Our File: EA1415-01

CanZinc responded to the first round of information request (IR) on May 9th, 2016. Some of the responses were not input into the online review system table but rather input as an attachment. The IR responses that were attachments to individual IRs have been compiled here into one pdf document to assist parties. The individual IR responses included are:

Figure A14

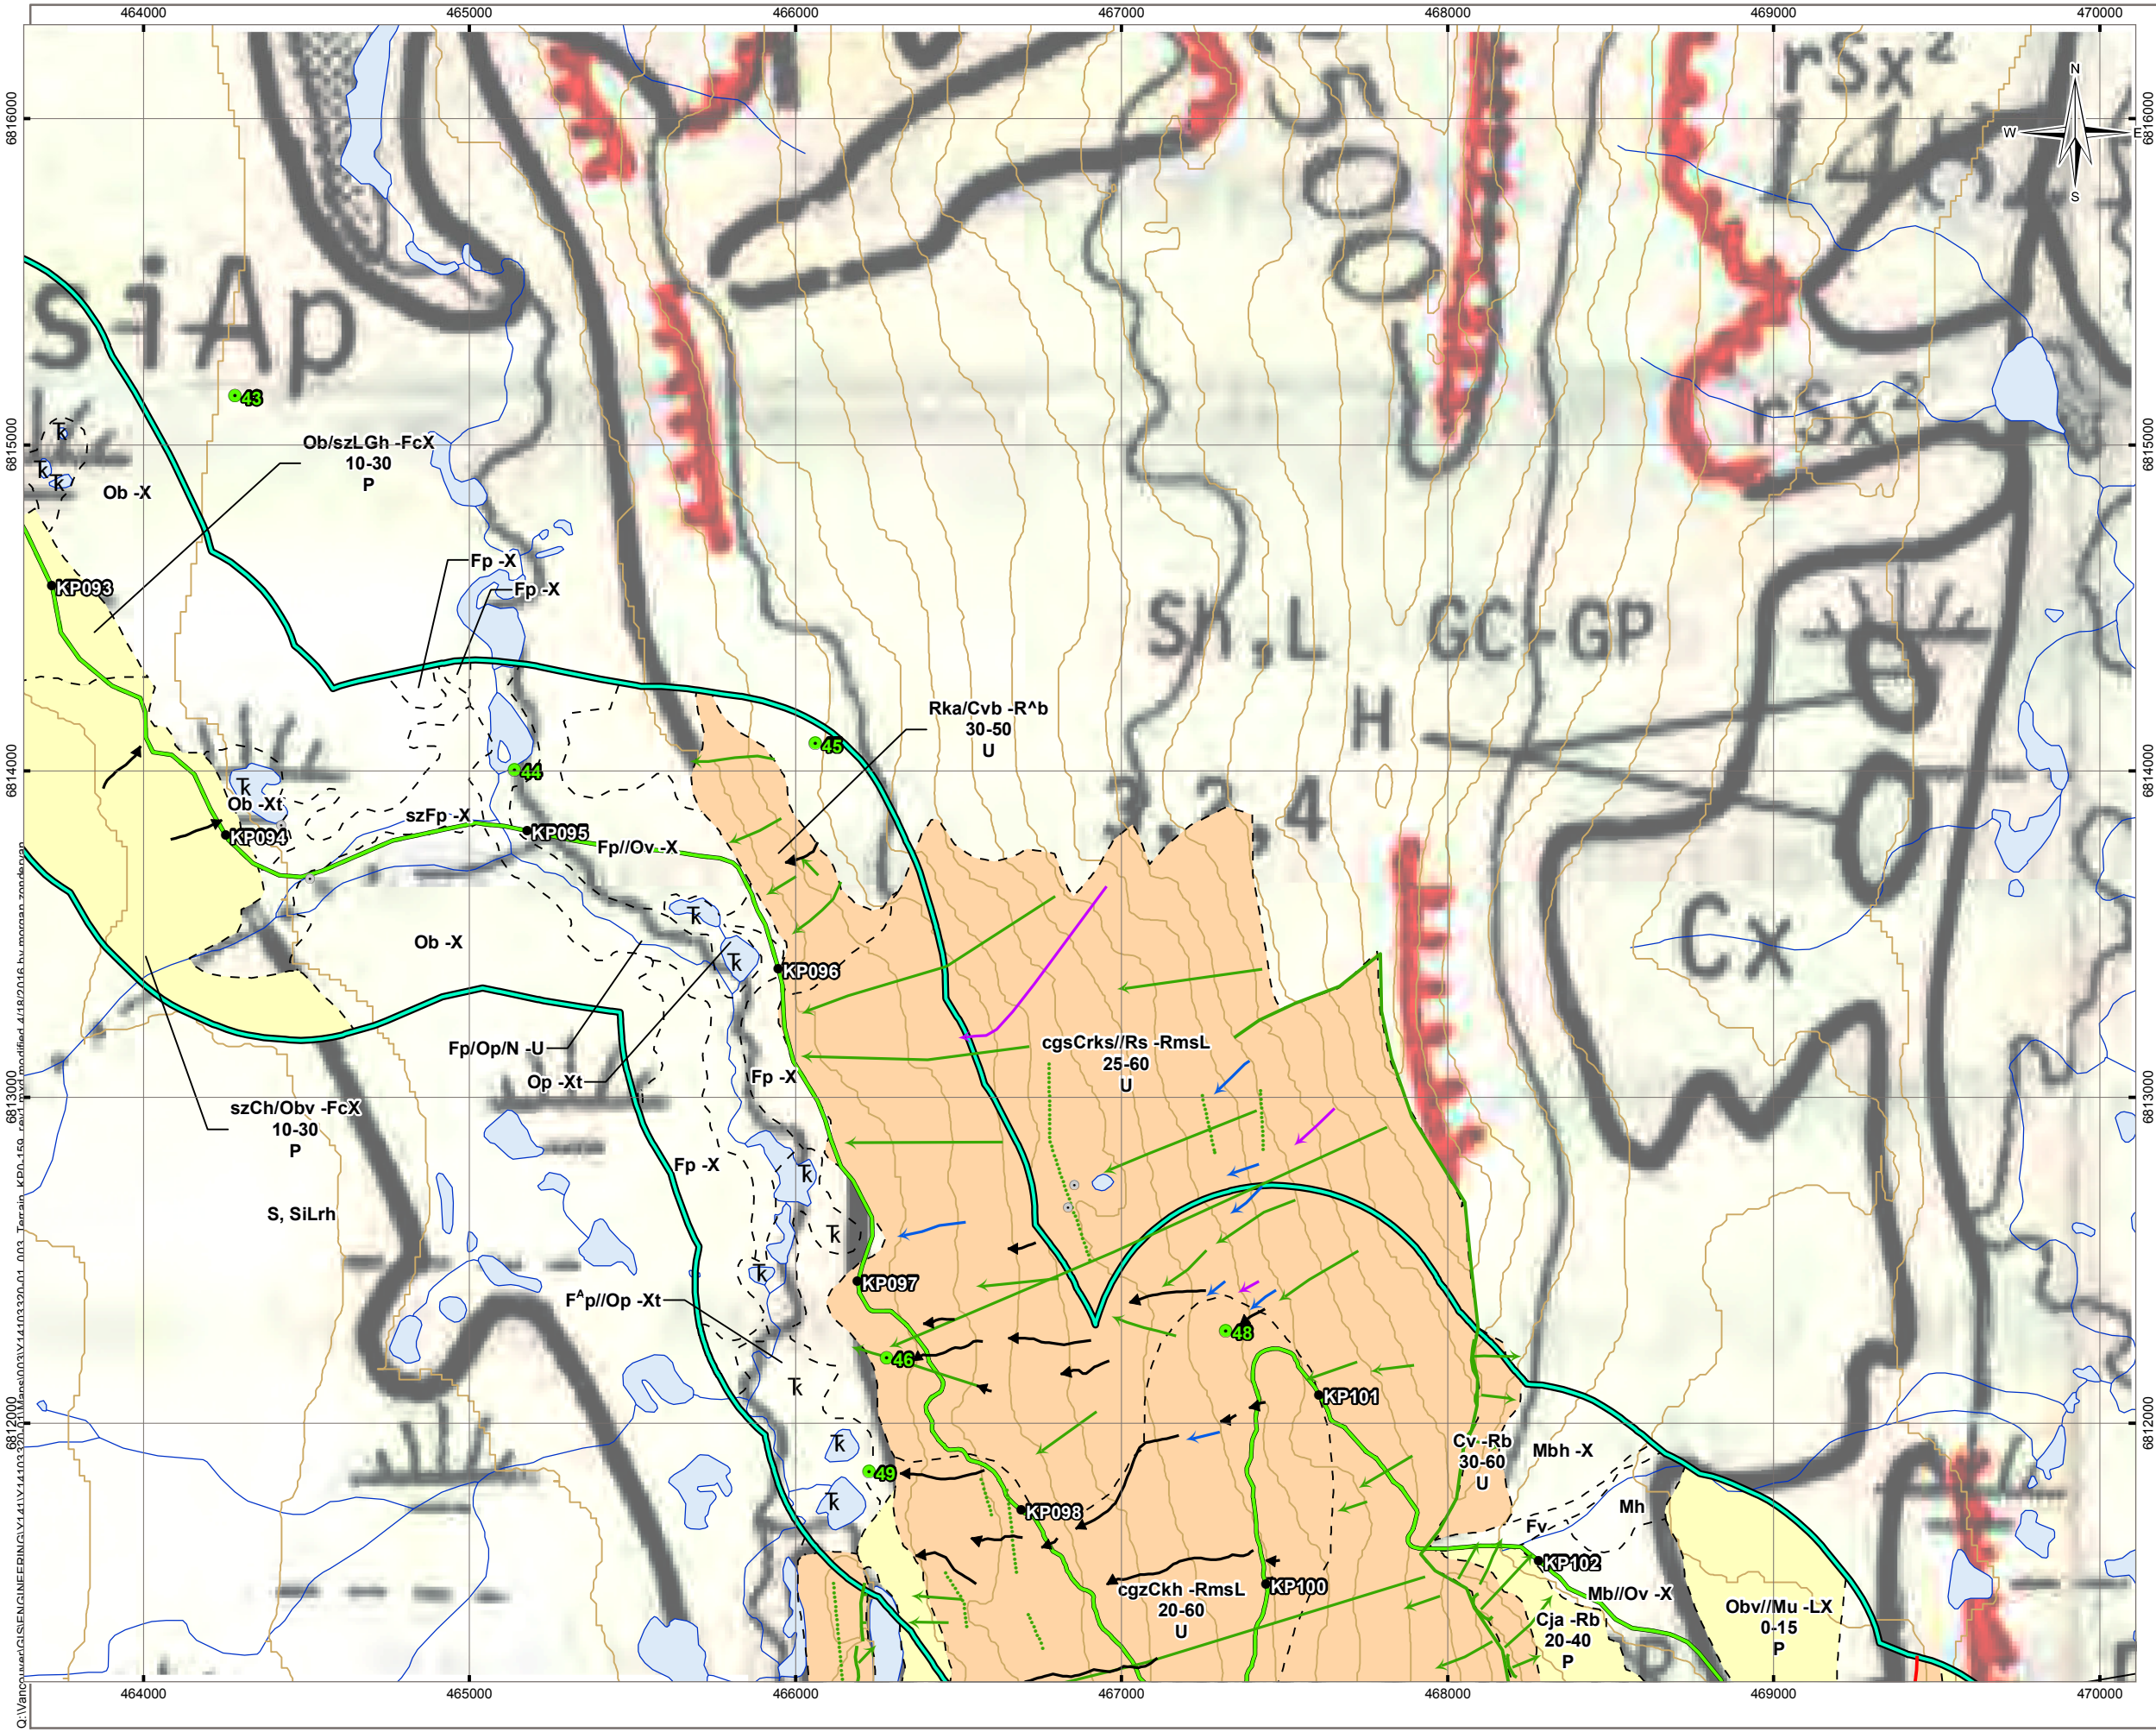
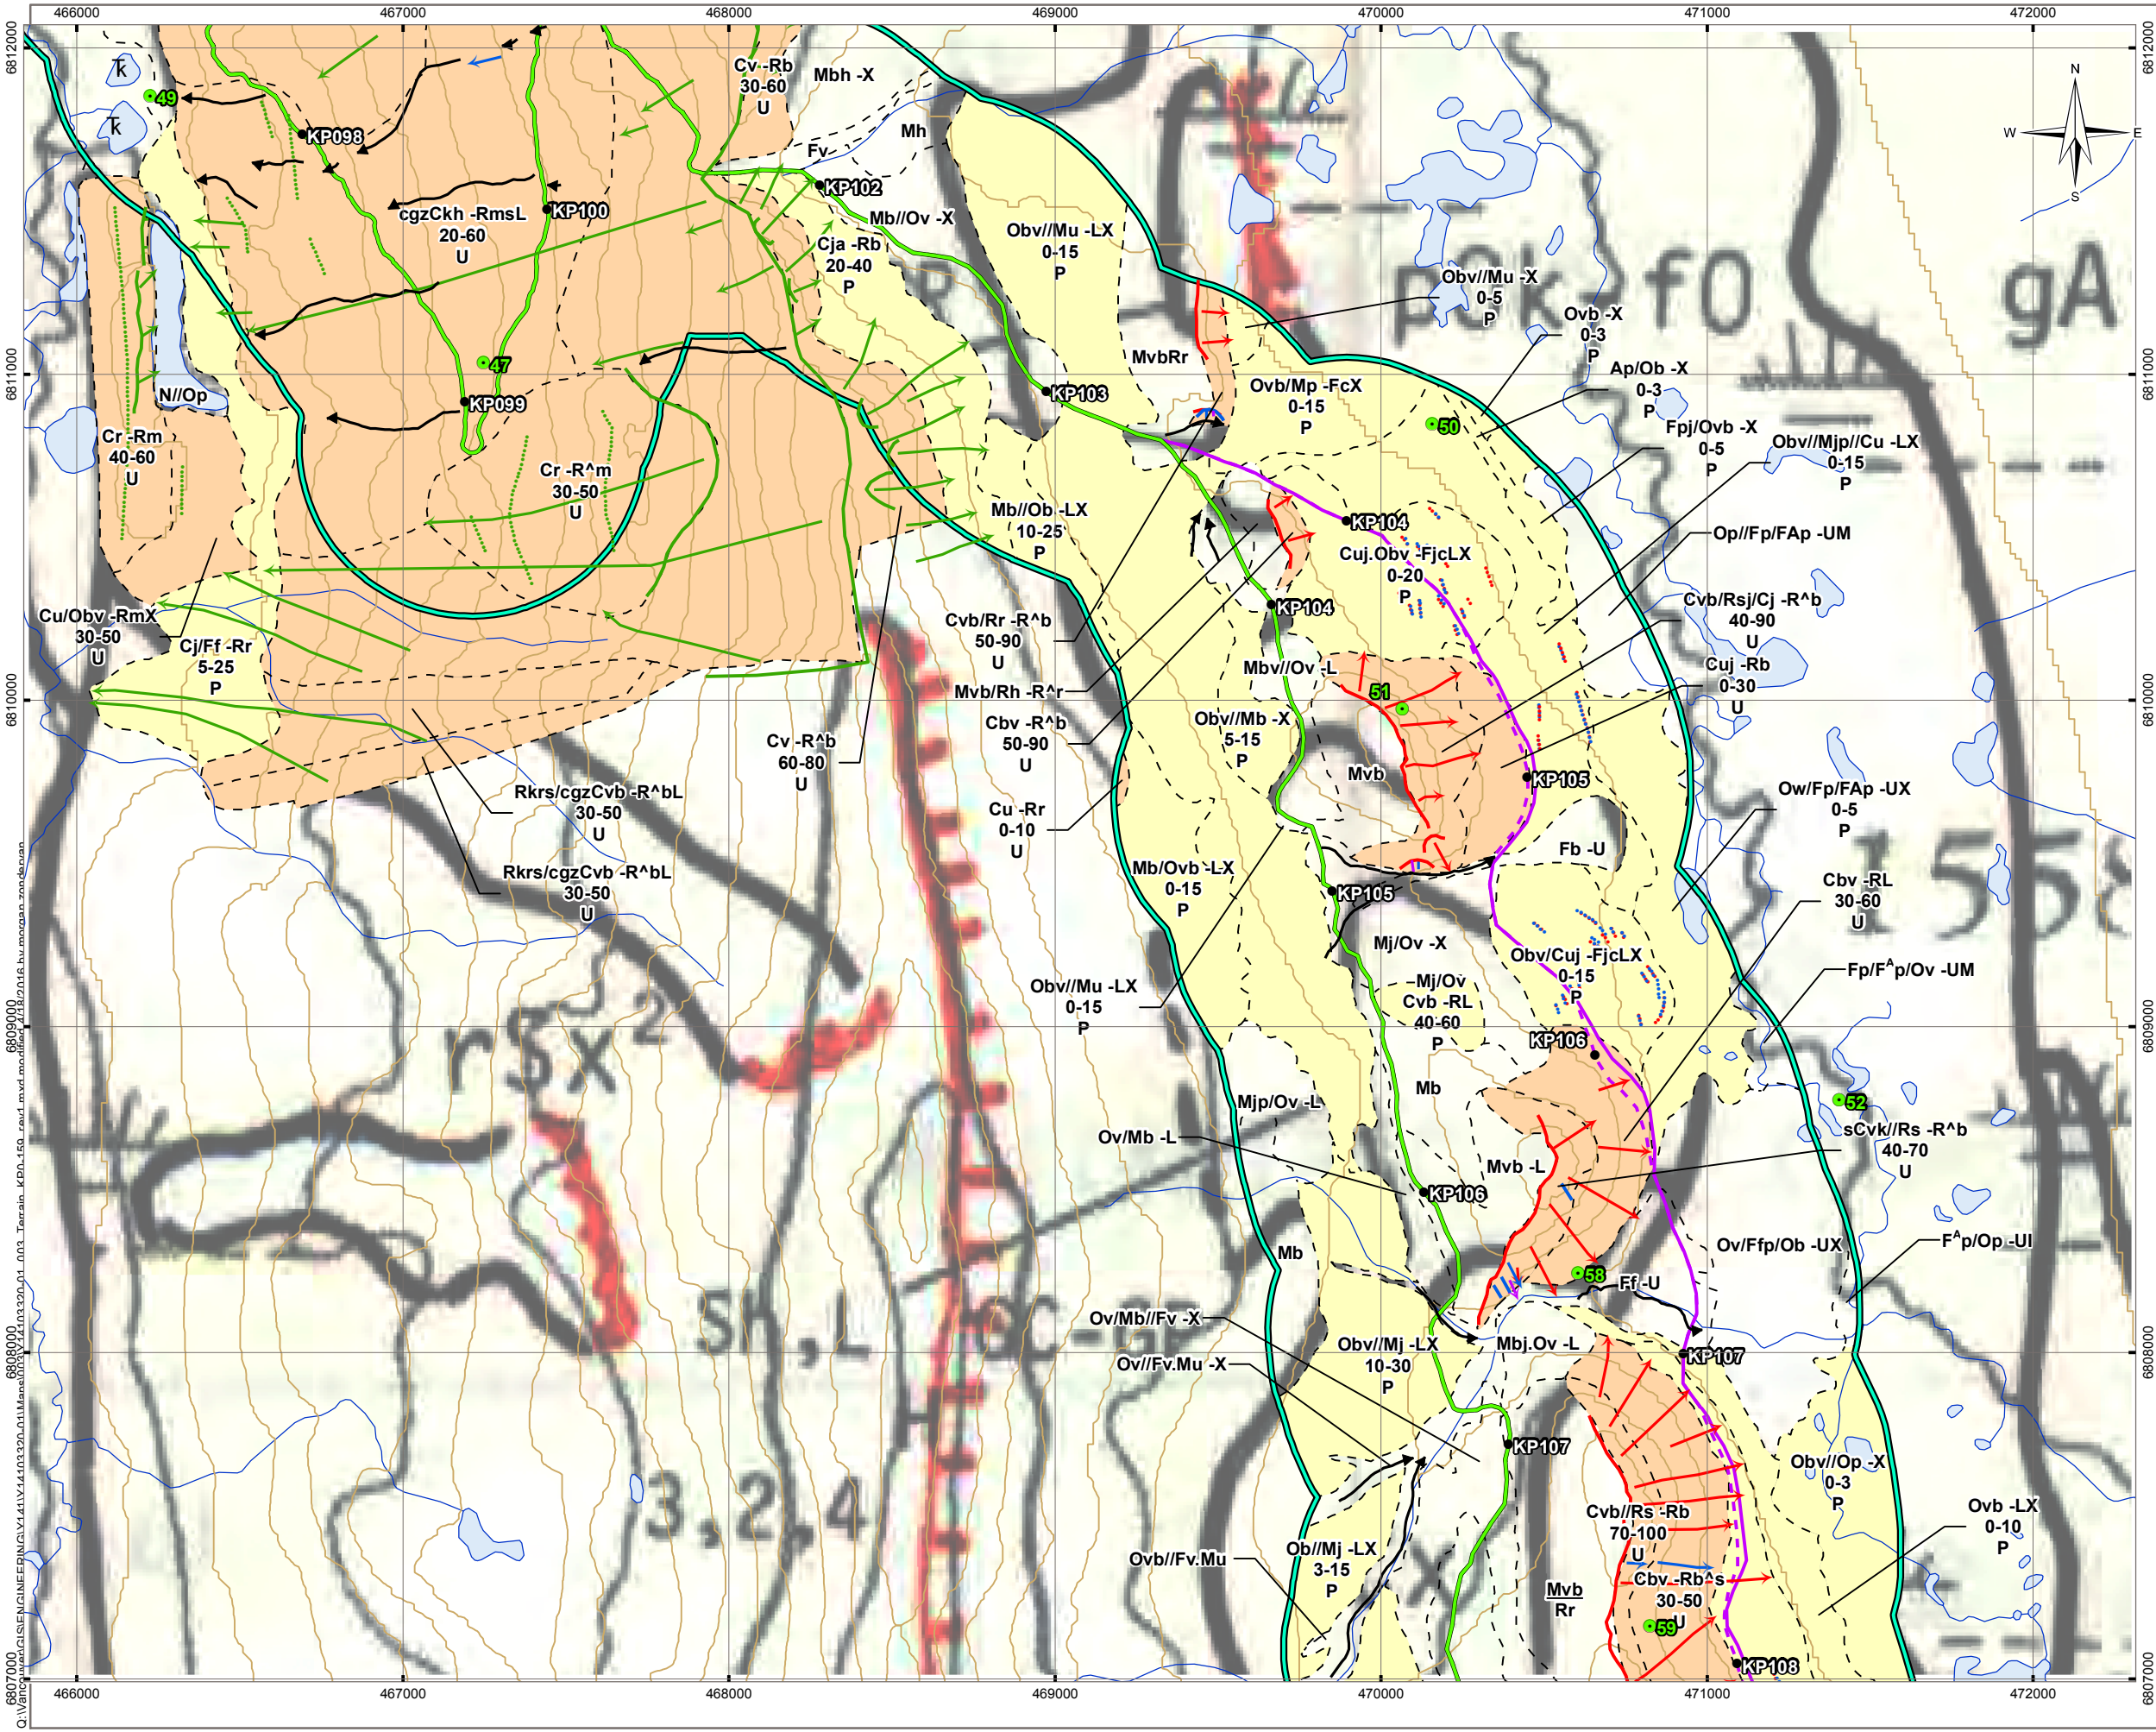
- iv) *“At KP 92.5 Km, there are ponds that have been previously identified as thermokarst ponds but are not highlighted as such in the mapping”.* These ponds are not identified as thermokarst in Rutter and Boydell (1981); however, the area does appear to be underlain by permafrost, and there is some change in pond shape between 1949 and 1994. The large pond has expanded about 12 m on average (in various directions), while two of the smaller ponds have grown about 2 m. The smallest pond has decreased in size by about 2 m. We have added thermokarst symbols to the ponds and -Xt to the label of the polygons that they lie within. The nearby stream between KP95 and 98 has some bank edge ponds that resemble thermokarst ponds. We have also labelled these as -Xt. Figures A13 and A14 have been revised.

Figure A19

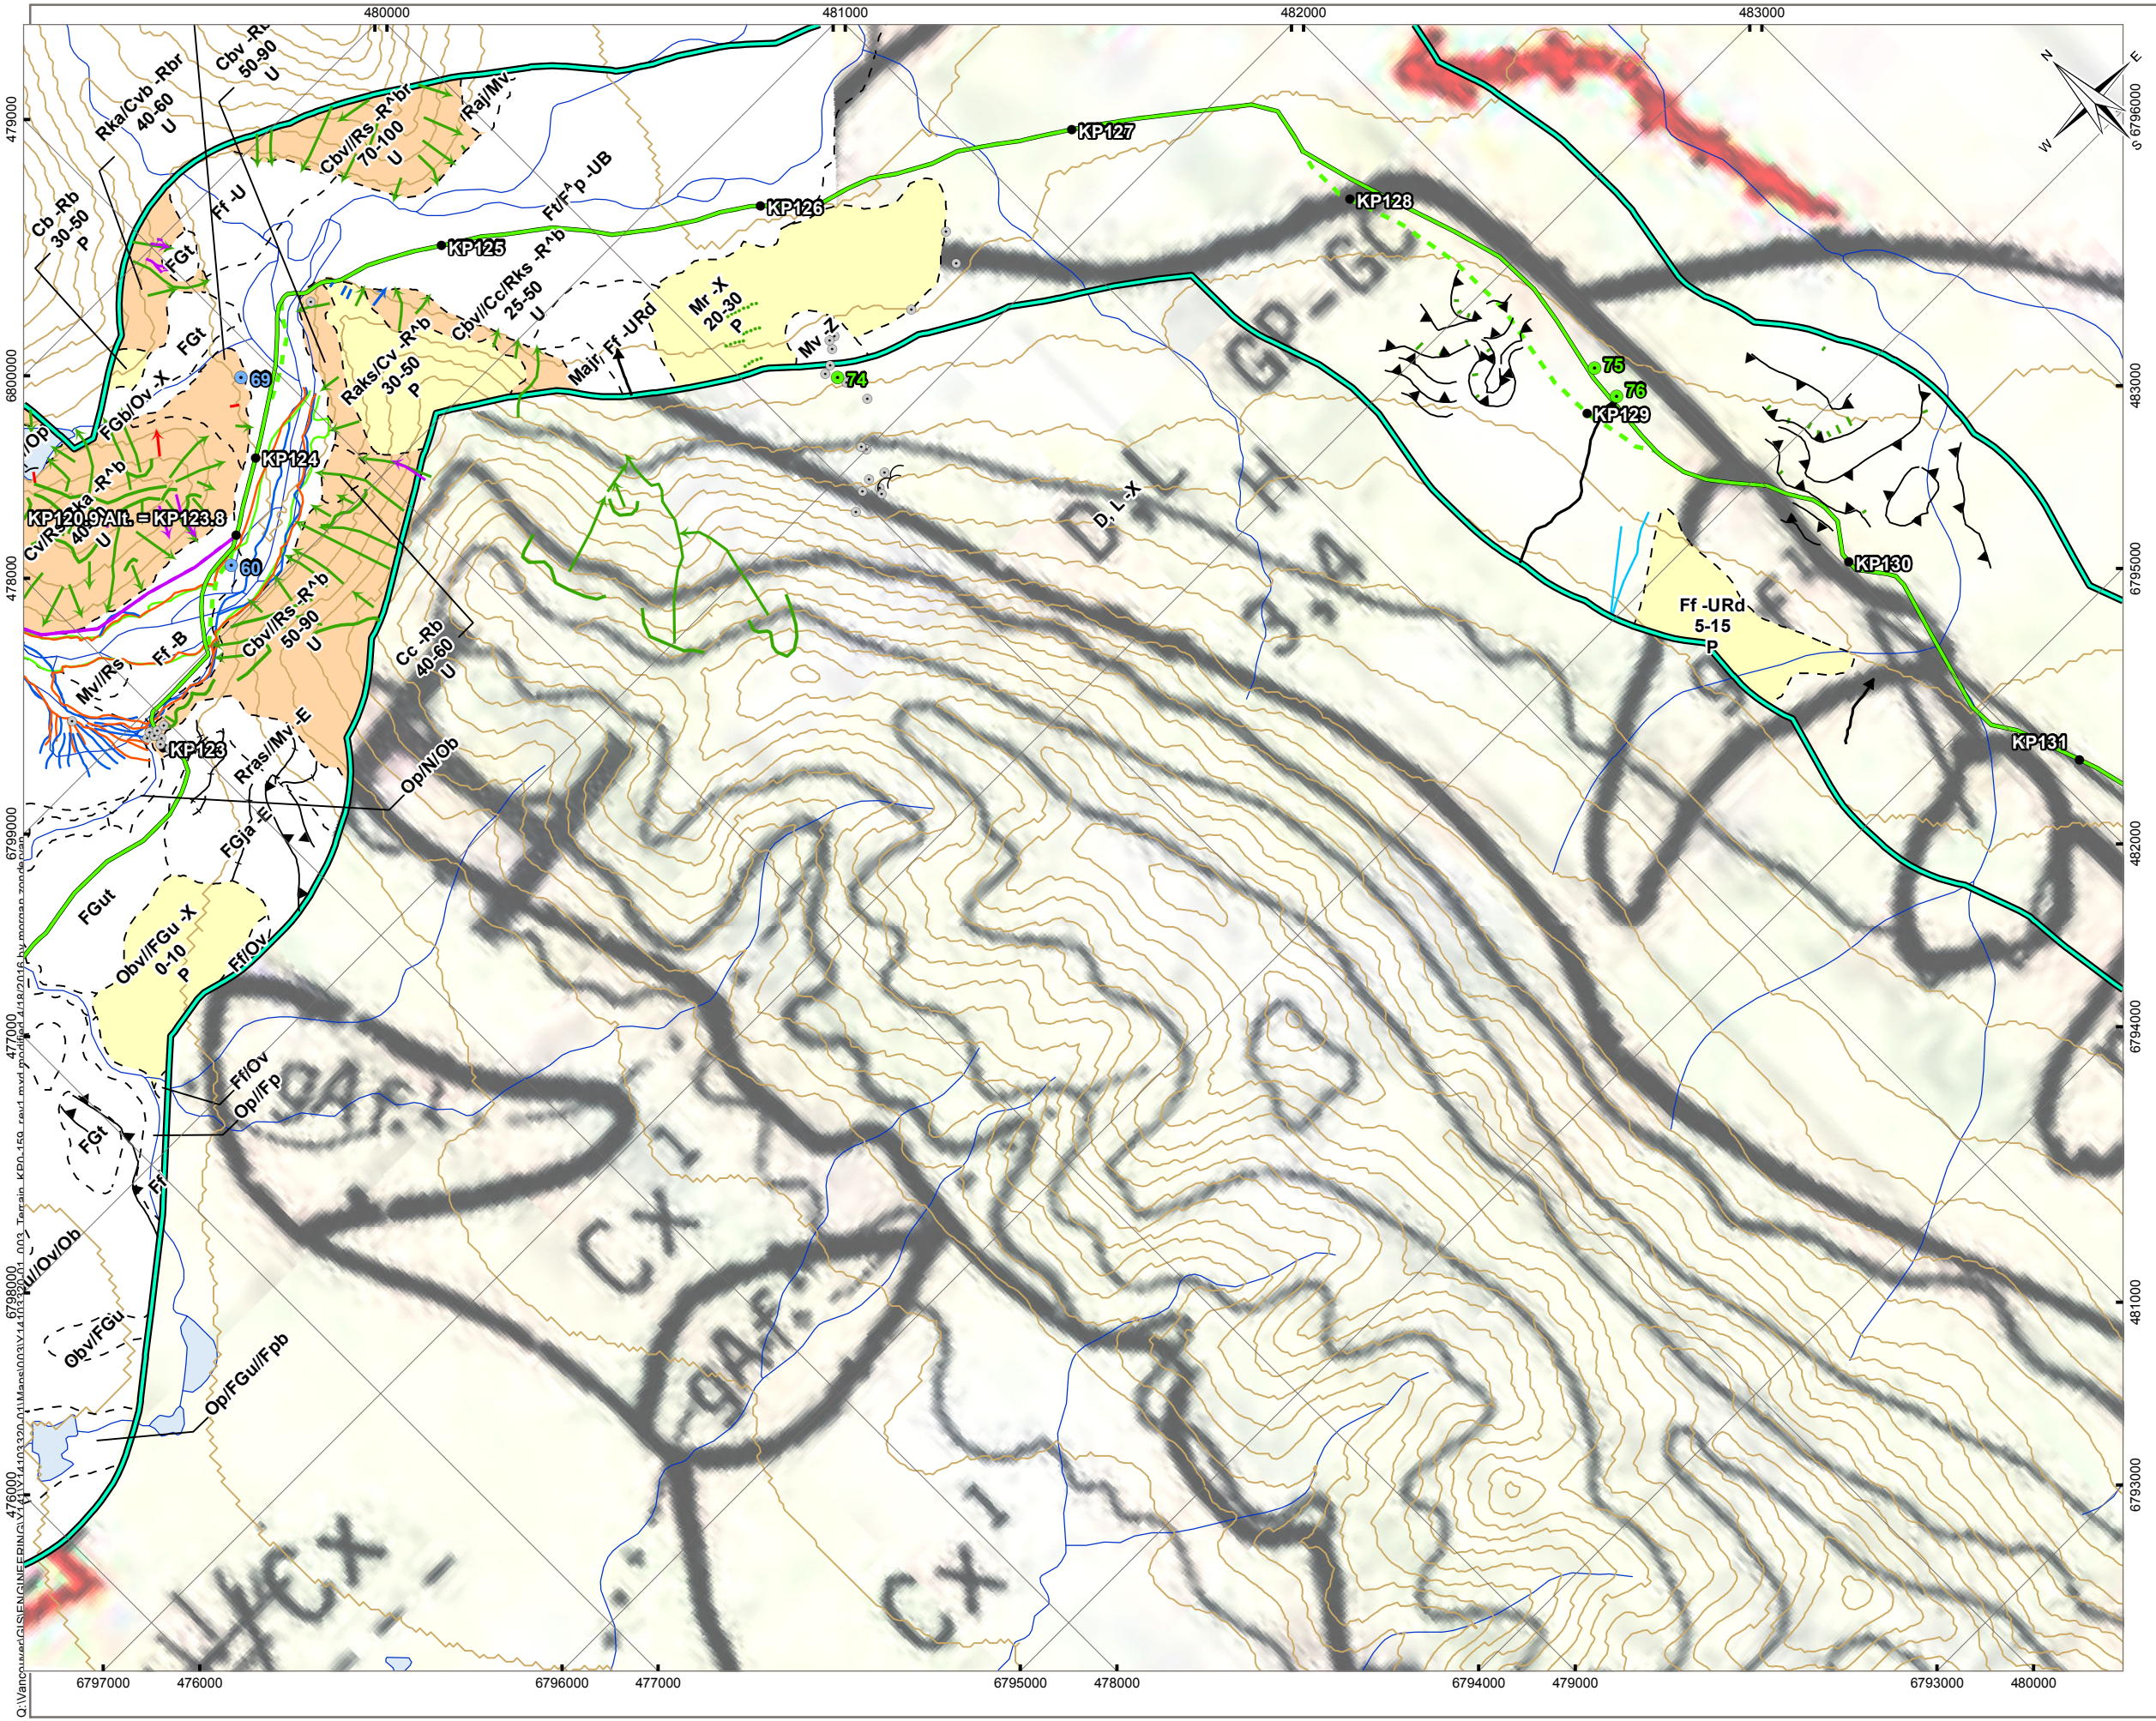
- viii) *“At KP 118.5 Km, permafrost is described in the text but does not appear to be included in the polygon mapping. Additional mapping characterizations and ground-truthing are needed to understand the nature and extent of permafrost at the site”.* A permafrost process designation has been added to the polygon in question. Figure A19 has been revised.
